SUBJECT: NRC STAFF'S PRELIMINARY FINDINGS REGARDING EXELON
GENERATION'S (EXELON'S) PROPOSED LICENSING APPROACH FOR THE
PEBBLE BED MODULAR REACTOR (PBMR)

Project No. 713

Staff Preliminary Assessment of Exelon's Proposed Licensing Approach

Figure 1

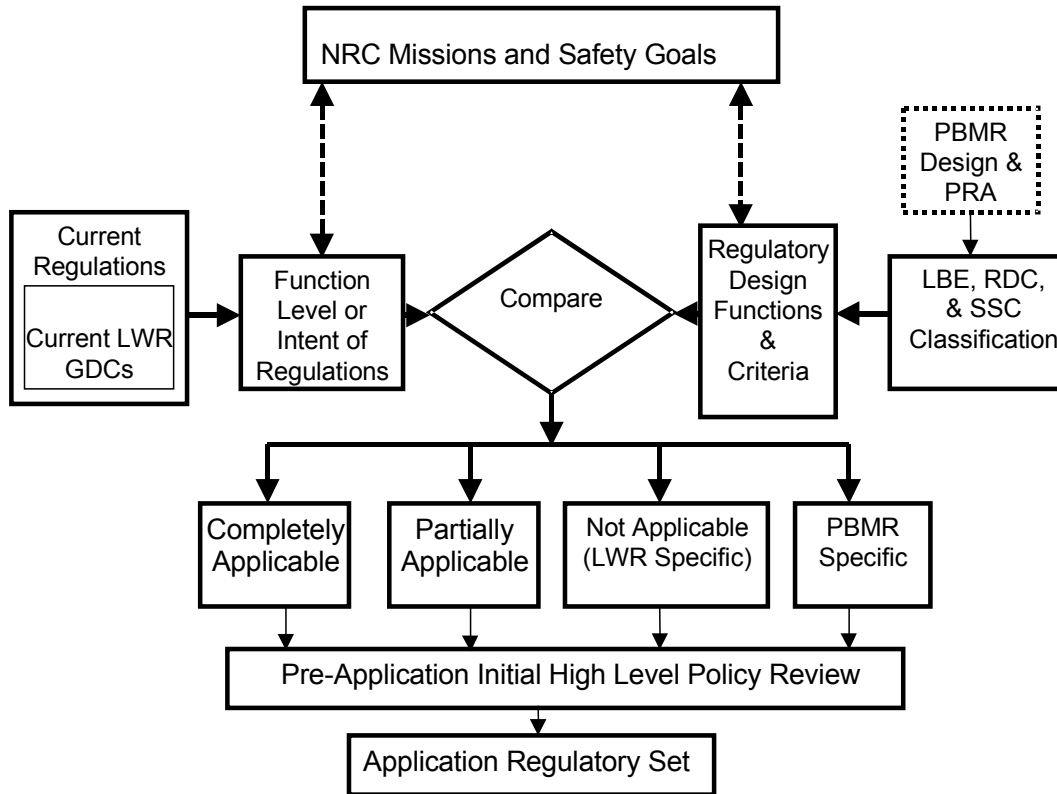
The staff recognizes that this process only addresses the regulatory issues that have been identified as part of the development of LWR regulations. This is why the information represented by the boxes on the top right of Figure 1 concerning regulatory design functions and criteria is needed to fully elicit and identify PBMR-specific issues.

In the absence of design details that are required for a final PRA, the applicant must make assumptions regarding the design and performance of various systems (in consideration of the right-hand side of Figure 1); these assumptions need to be explicitly identified so as to make the applicant accountable for validating them.

Figure 2

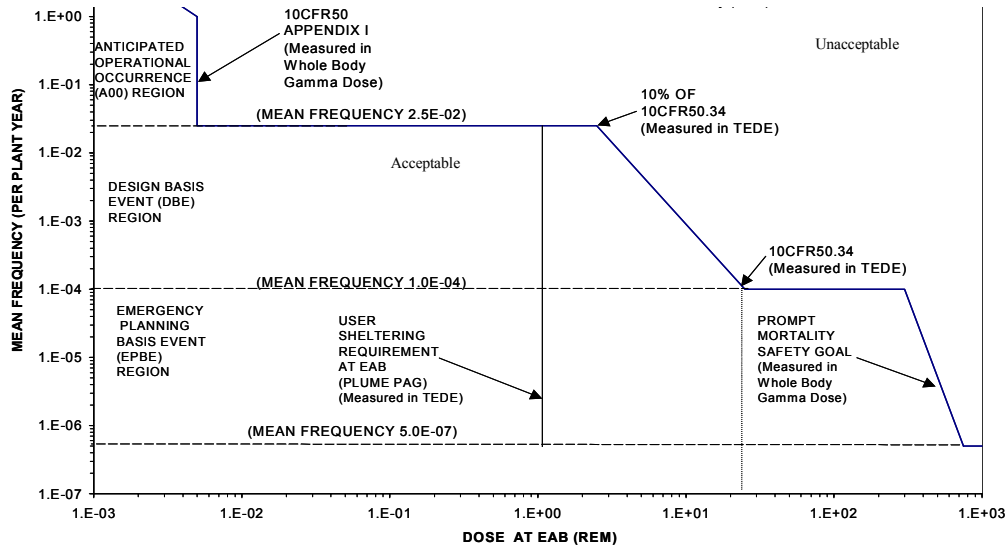
Exelon's proposed licensing approach, as it relates to applicability of NRC regulations, focuses on the safety regulations contained in the current 10 CFR Part 50. Exelon's plotting of the TLRC is consistent with past principles, but poses technical challenges, such as determining the appropriate frequency ranges applicable to each of the regions. The current regulations include a frequency reference for the definition of AOOs, but do not contain a similar reference for DBEs. Exelon has chosen 1×10^{-4} per plant year as the lower frequency for a DBE. The staff will continue to assess the appropriateness of this value and its consistency with current practice and the criteria contained in SECY-00-198 which discusses RIP 50 Option 3, taking into account such considerations as cumulative effects (for the families of events and for multiple modules) and the frequency ranges considered in other advanced reactor reviews. In the event that such technical questions arise, they might have concomitant policy implications which could require Commission guidance before such questions can be resolved. Some of these technical and policy issues have been identified in this assessment, but more could arise as the staff's pre-application review proceeds. For example, the TLRC use one of the quantitative health objectives (QHO) from the Commission's safety goal policy (i.e., the risk of prompt fatality); however, the other QHO on latent cancer risk is not addressed. The staff expects continued interactions with Exelon to help clarify some issues.

The staff notes that plotting of TLRC is useful to illustrate bounding criteria and safety margins. However, the licensing basis is the set of requirements that are applied to the safety-related equipment to meet the LBEs (or other special regulatory objectives such as anticipated transients without scram (ATWS) or station black-out (SBO)); simply falling within the plot of the TLRC does not in itself constitute a complete licensing basis. Moreover, while the PRA confirms risk insights for a design, and can be used for other purposes as noted above, licensing activities will be a mix of “deterministic” analysis supplemented with risk insights. The lack of operational data for some of the unique PBMR SSCs makes complete reliance on PRA difficult.

Figure 3
Radionuclide Retention Functions for the MHTGR

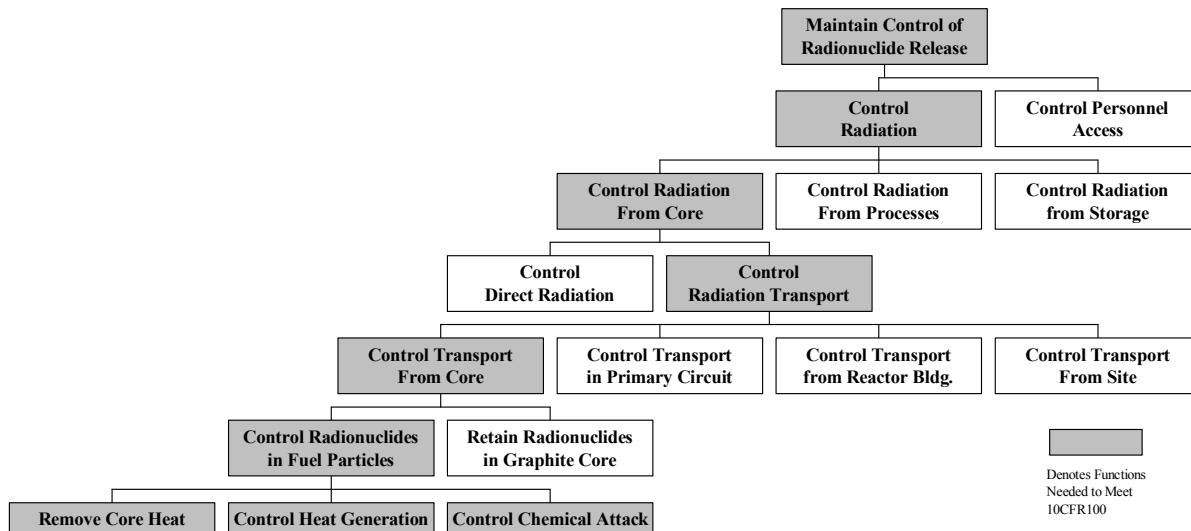
While the staff understands that this is not a PBMR-specific figure, the figure seems to imply that the function can be met without controlling radionuclide transport from the reactor building and from the site, which appears to contradict the defense-in-depth philosophy. The role of a containment in the PBMR design will be specifically addressed and is expected to be presented to the Commission as a policy issue. The staff believes that system redundancy, defense-in-depth, and maintenance of safety margins should be incorporated into the process for categorizing SSCs as safety-related. The staff will continue to discuss these concerns with Exelon in its pre-application review.
